**4702 West Virginia Avenue  
Design Advisory Panel Submittal (Site Plan)**

## **II. Previous Design Advisory Panel Recommendations**

**4702 West Virginia Ave  
Bethesda, MD**

**Pre-Submission Site Plan  
Design Advisory Panel**

2nd, 3rd and Roof Plans

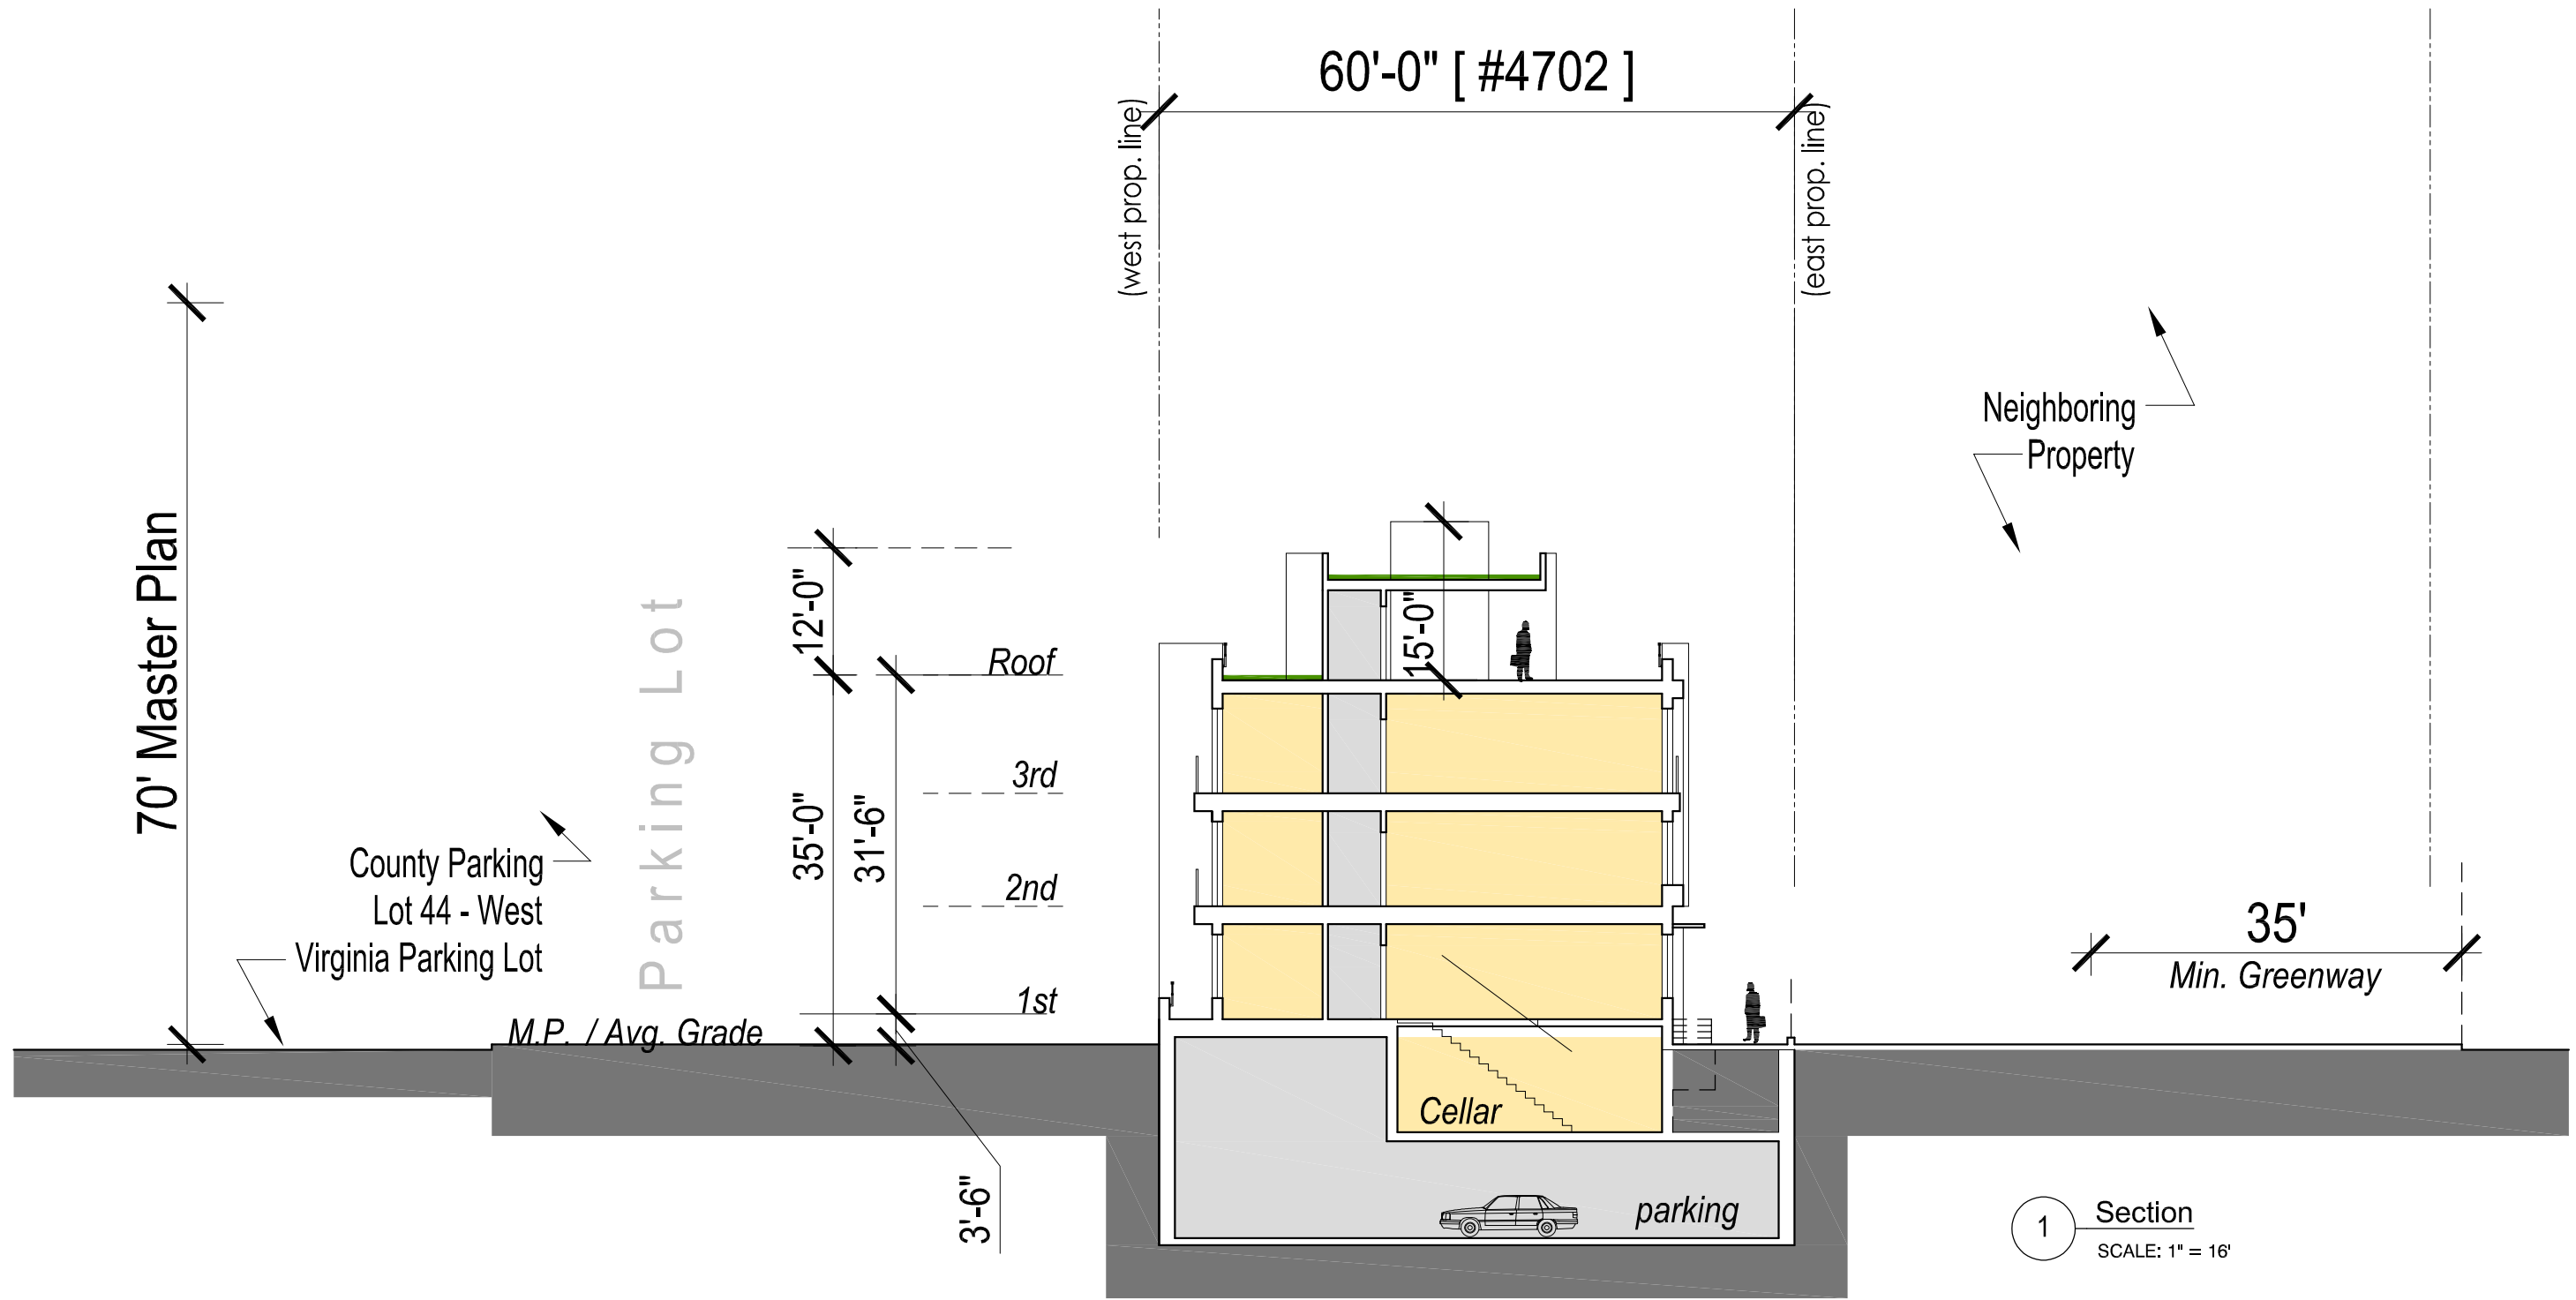
**DAP Recommendation 1.** Provide more depth to all elevations. In particular, design the west elevation with more articulation and no blank panels. Incorporate elements such as balconies and windows

Notwithstanding the foregoing, the Applicant has redesigned the western elevation with windows and transparency to the maximum extent feasible under the Building Code. The western elevation also incorporates several balconies to further activate this frontage. The proposed design incorporates a different palette of materials which give greater contrast and more visual depth to the project. The base of the building will be masonry which will provide visual weight and a textural difference between the floors above. Balconies have been included in the façade, and also the roof line of the building has been updated to provide variety of heights. The combined effect of the material changes, changes in planes and depth reinforces the corner expressions on the northeast and southeast corners of the Project and allow for the building to read as a whole with the various facades interacting with each other. The redesigned western façade is consistent with

Section 2.4.1.B of the Design Guidelines by including elements such as fine-grain building articulation, variations in wall planes, colors, materials and textures, which also addresses the DAP’s recommendation.
